# Addendum 02

**PROJECT:** Riverside Local School District  
Central Office and Health Clinic Addition  
2096 County Road 24 S  
De Graff, Ohio 43318

**PROJECT #:** 22071-00

SHEET NUMBER:  
**E1.4**

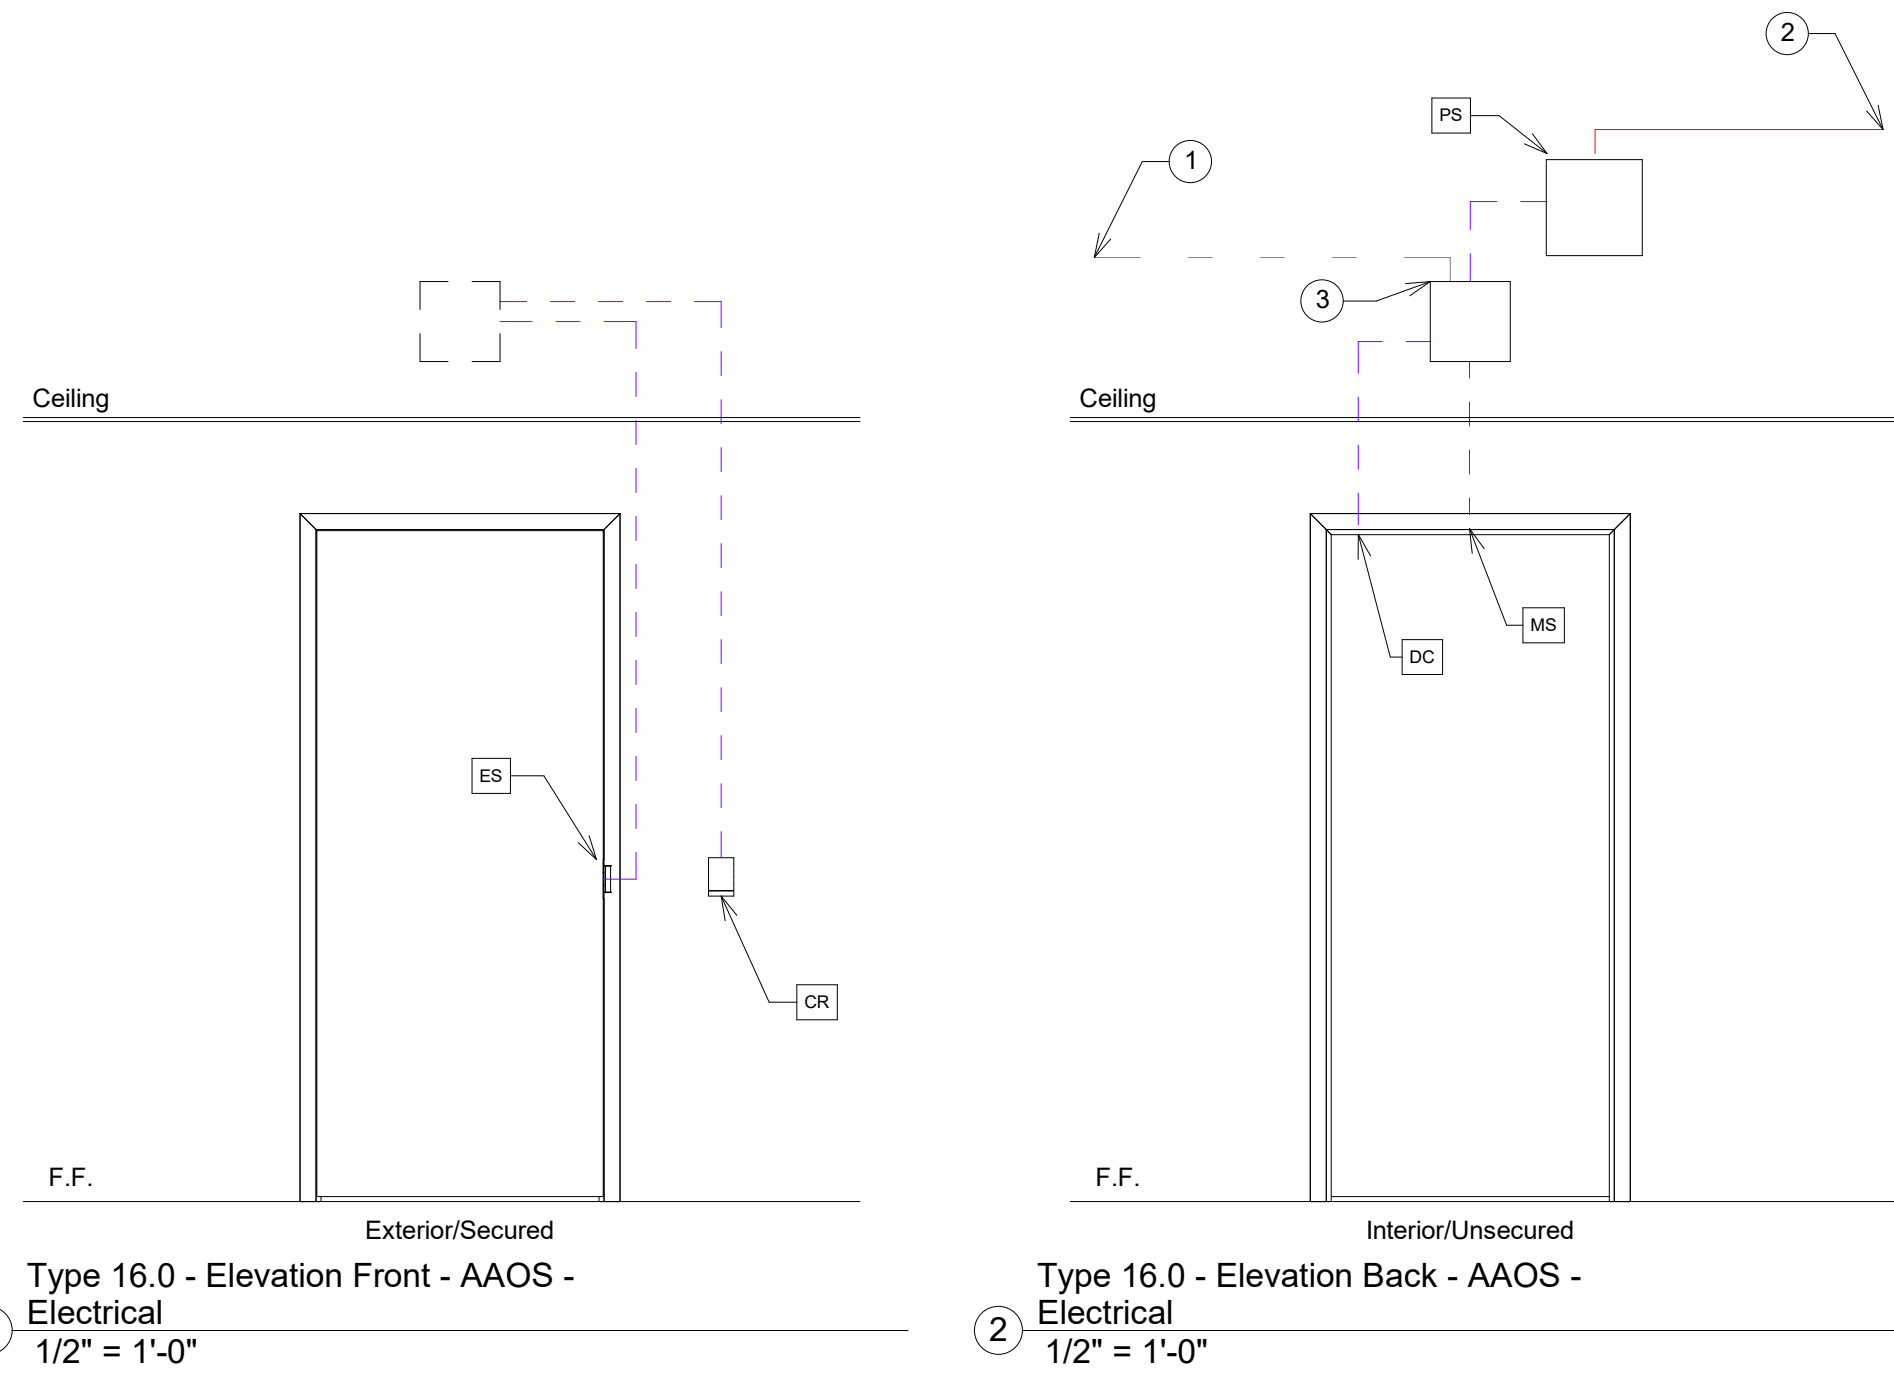
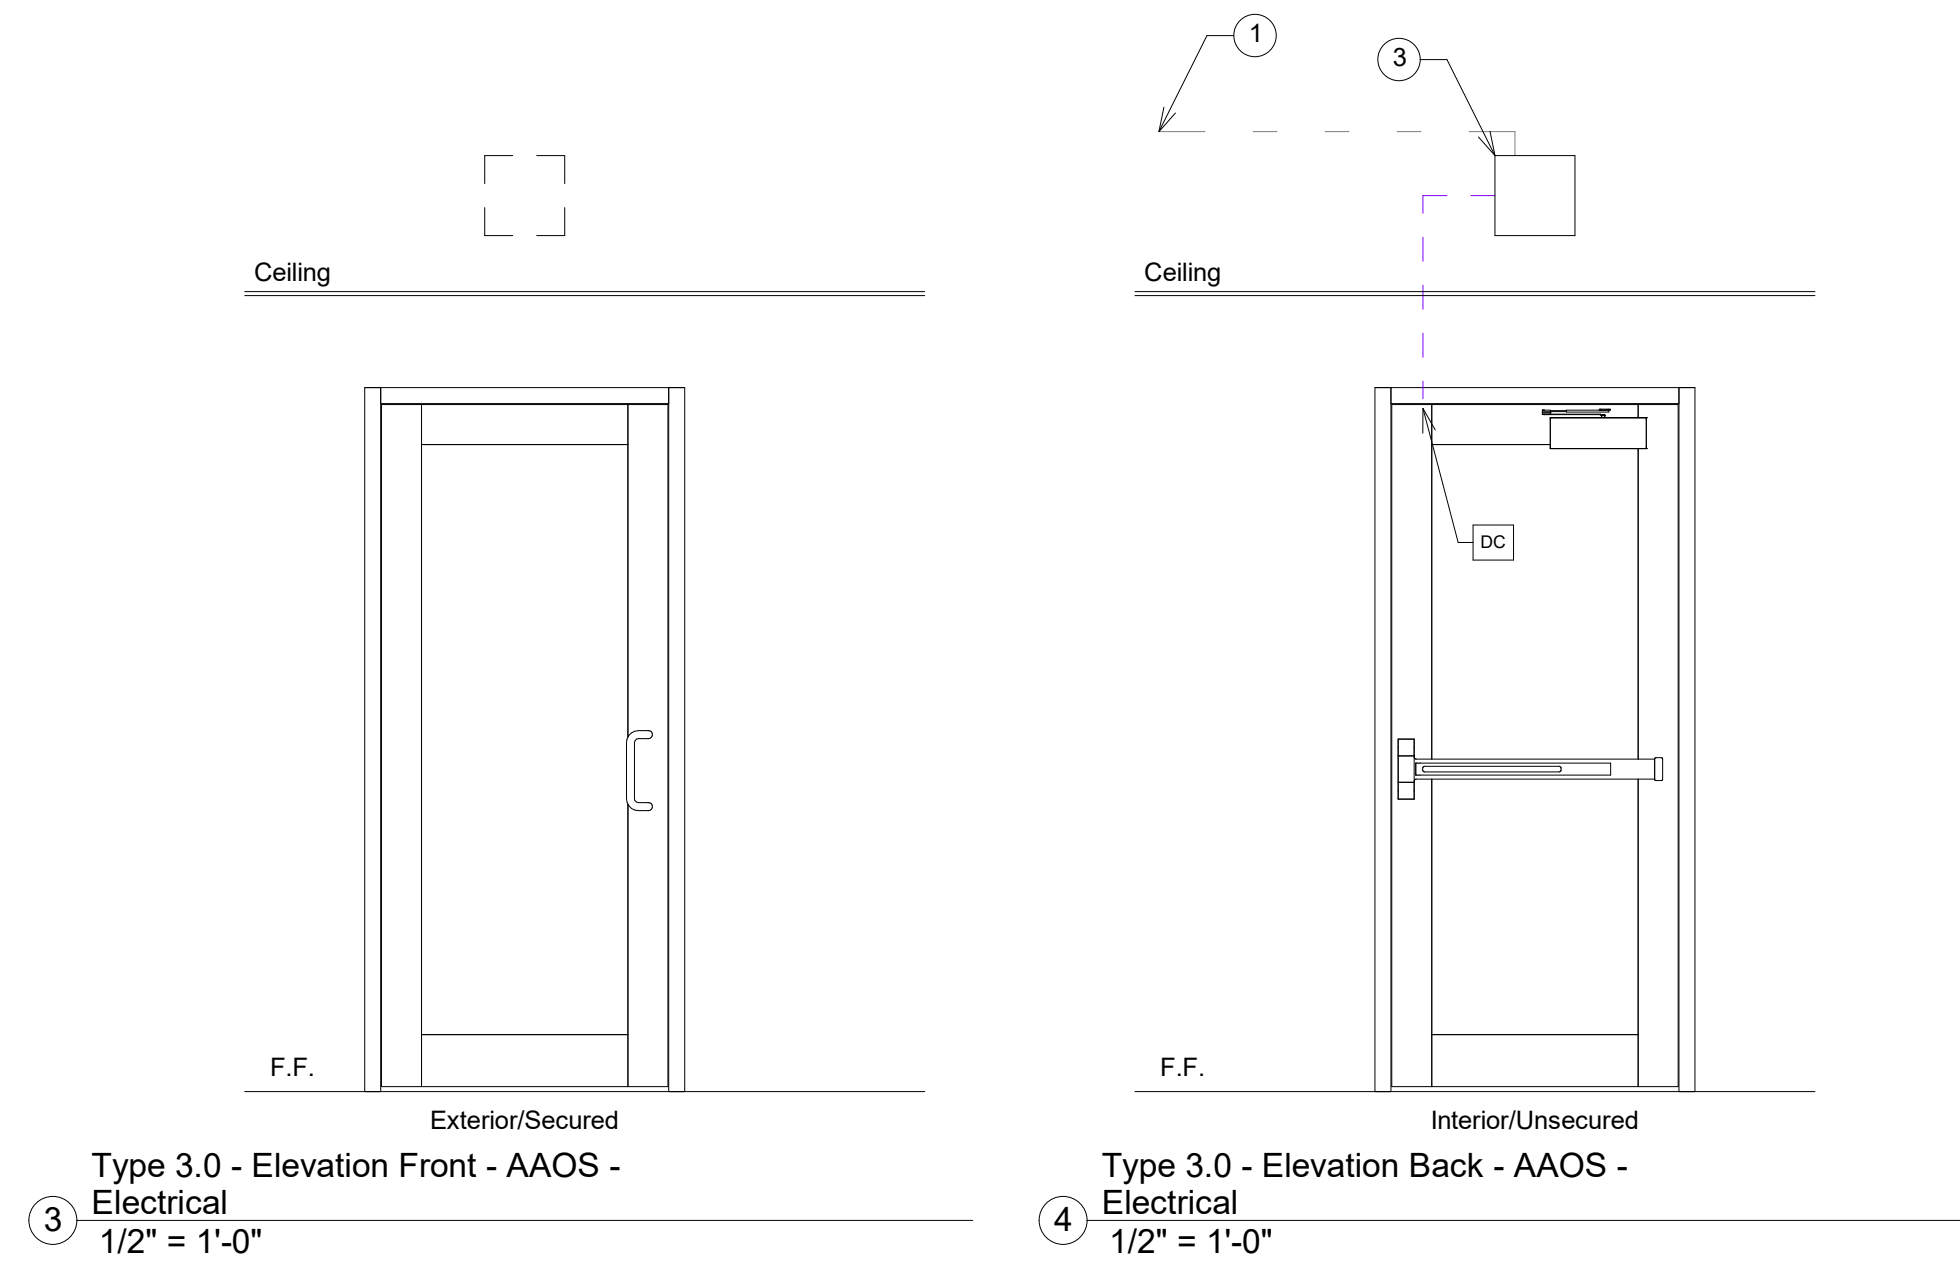
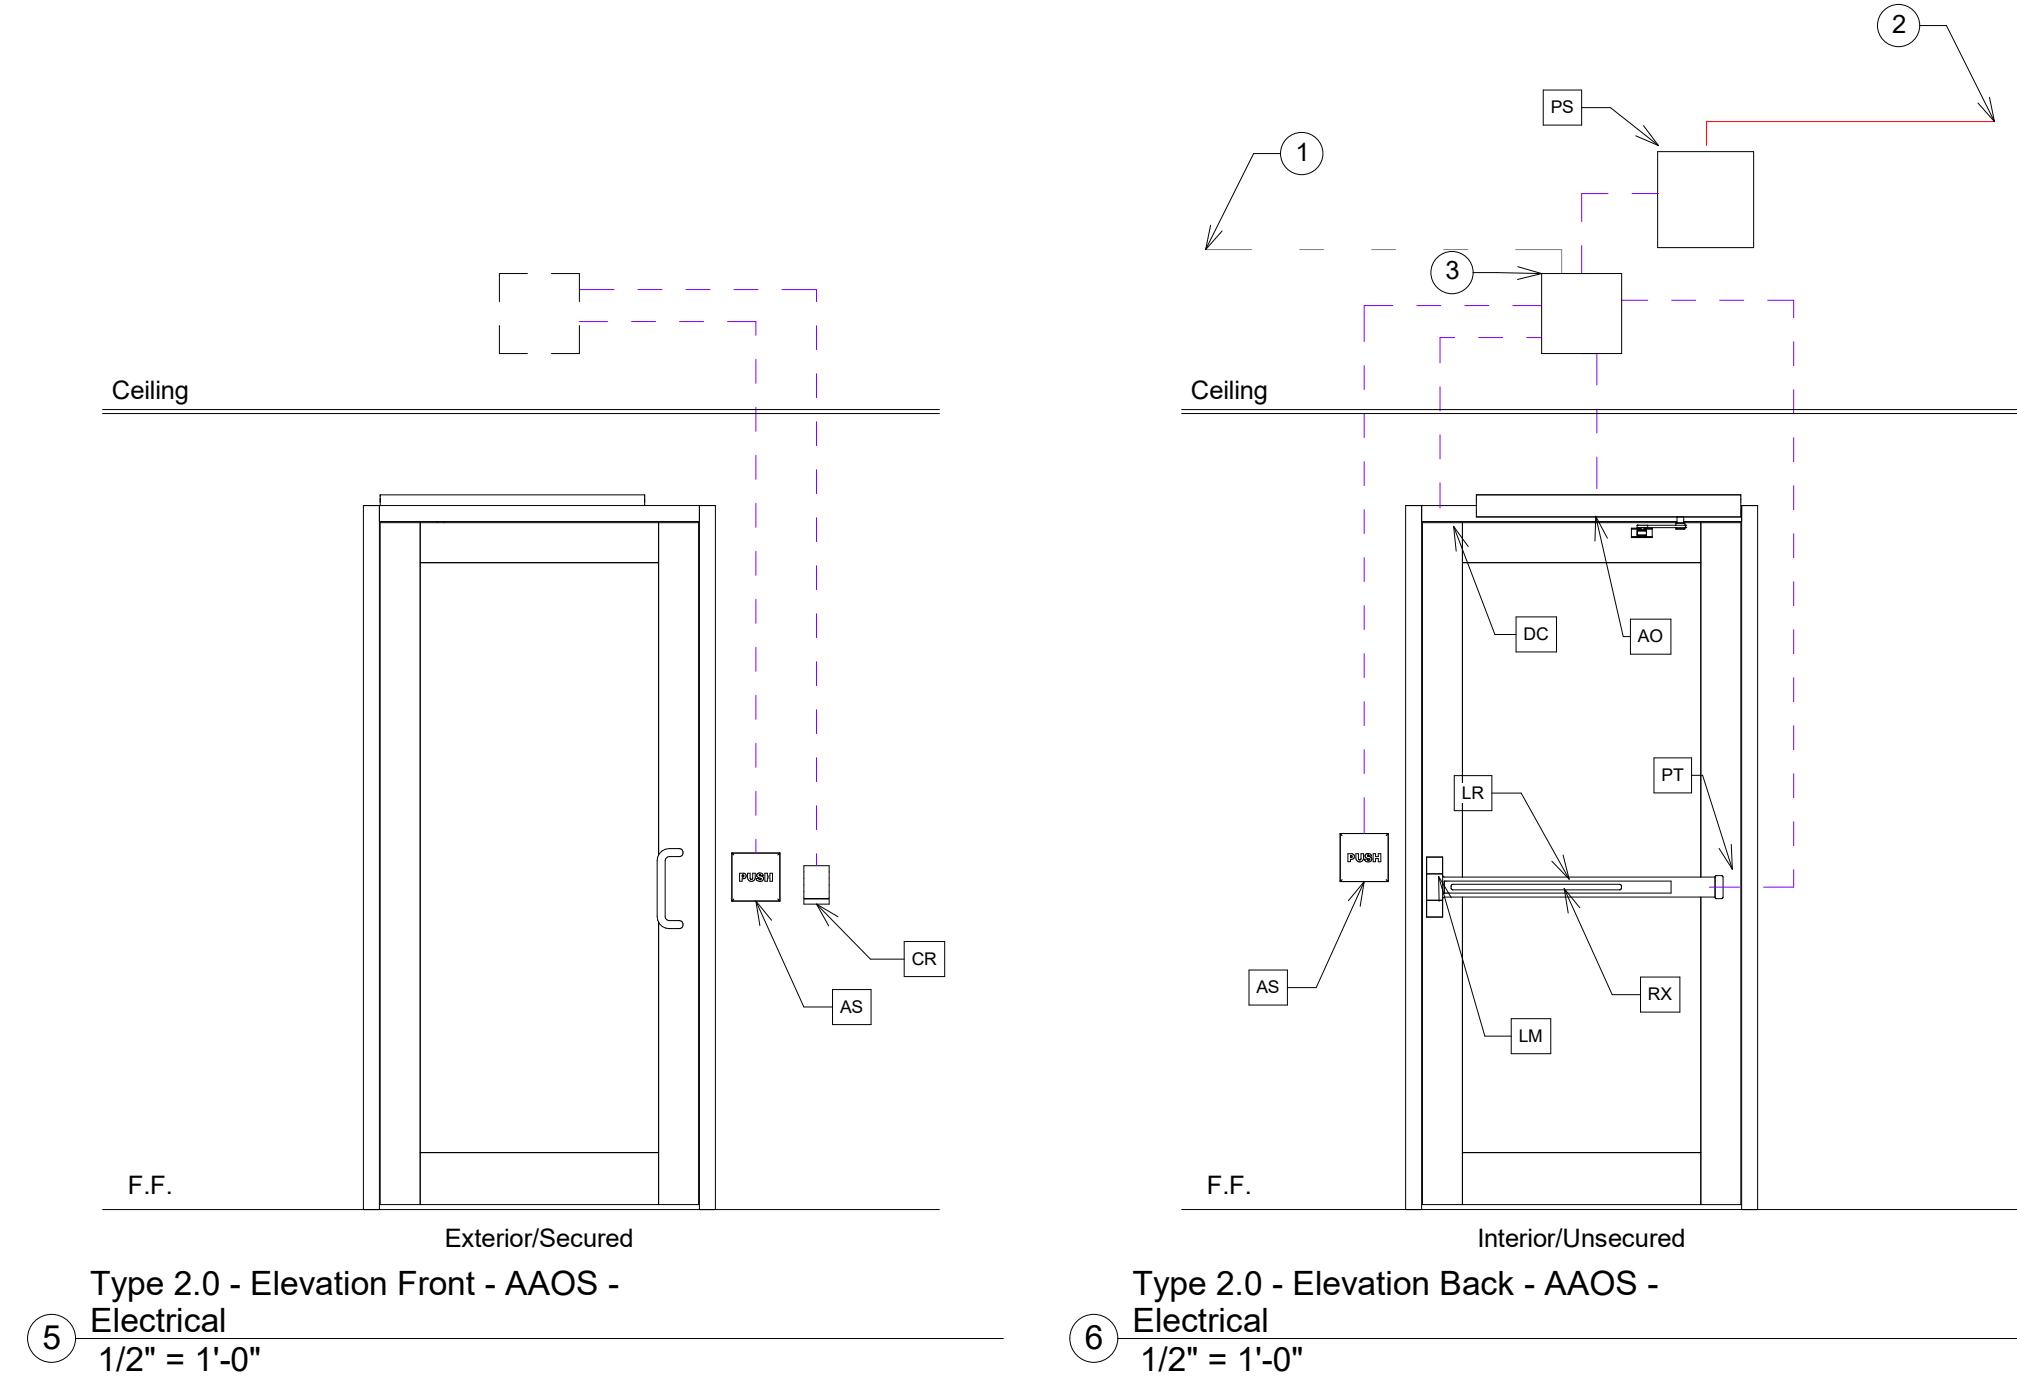
1. Add drawing Sheet E1.3 EAC Security Elevations in its entirety. Reference sheet attached.
2. Add drawing Sheet E1.4 EAC Security Elevations in its entirety. Reference sheet attached.
